Pavilion H Infusion Center Relocation

ADDENDUM # 1

10/31/2024

Purpose Addendum #1

1 FIRST FLOOR HYDRONIC NEW WORK PLAN
M202 1/4\" = 1'-0"

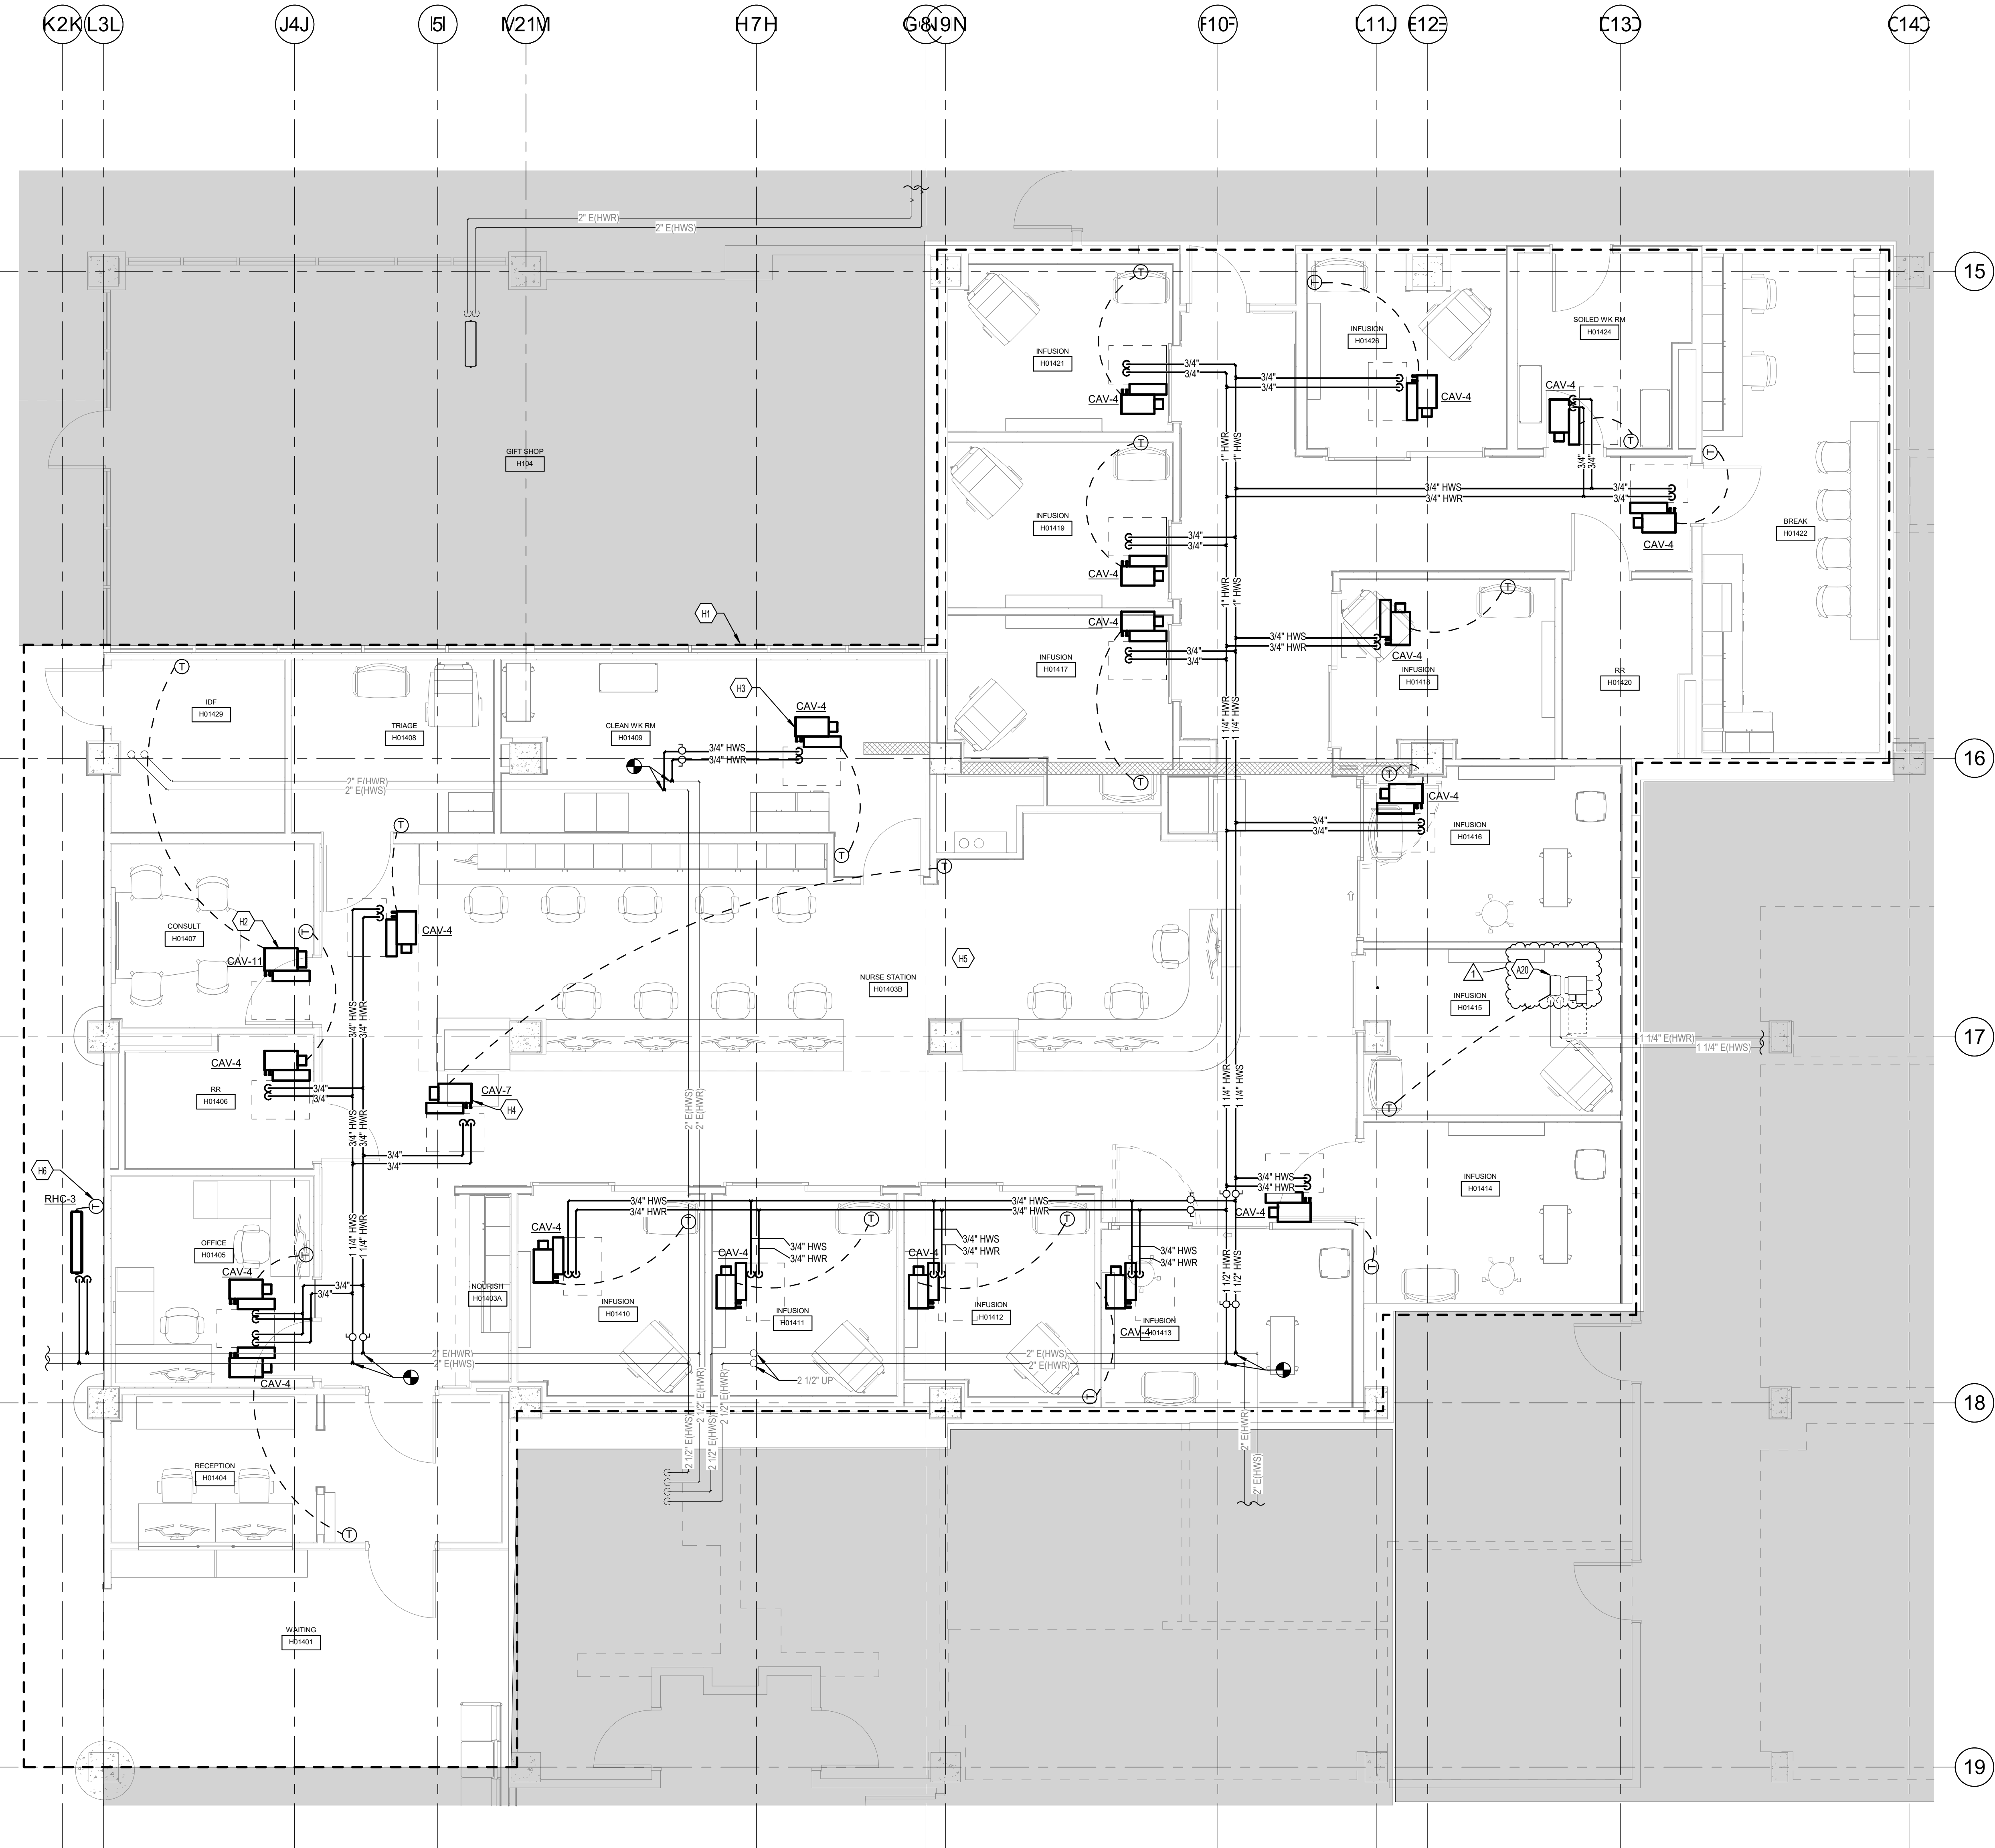
Item #3 Refer to the Mechanical Sheets M102 First Floor Hydronics Demolition Plan and M202 First Floor Hydronic New Work Plan

- A. Tagged Note A20 stating existing CAV and reheat coil to remain and be reused. Refer to attached drawing.

- TAGGED NOTES**
- A20 EXISTING CAV AND REHEAT COIL TO REMAIN AND BE REUSED.
- H1 PROJECT BOUNDARIES
- H2 COOLING ONLY CAV SERVING IDF ROOM. NO REHEAT COIL IS REQUIRED.
- H3 RHC-1 SHALL BE PROVIDED WITH ALL CAV-4 BOXES UNLESS OTHERWISE NOTED. REFER TO MECHANICAL SCHEDULES AND DETAIL SHEETS. TYPICAL.
- H4 RHC-2 SHALL BE PROVIDED WITH ALL CAV-7 BOXES UNLESS OTHERWISE NOTED. REFER TO MECHANICAL SCHEDULES AND DETAIL SHEETS. TYPICAL.
- H5 BM COORDINATION FOR ALL WORK SHOWN ON FIRE PROTECTION, MEDICAL GAS, PLUMBING, MECHANICAL, AND ELECTRICAL DRAWINGS IS REQUIRED FOR THIS PROJECT. REFER TO SPECIFICATION SECTION 20500 - COORDINATION AMONG TRADES, SYSTEMS, INTERFACING AND CONNECTION OF EQUIPMENT FURNISHED BY OTHERS.
- H6 PROVIDE THERMOSTAT TO SERVE RHC-3. COORDINATE THERMOSTAT LOCATION ON WALL WITH ENGINEER PRIOR TO ROUGH IN.
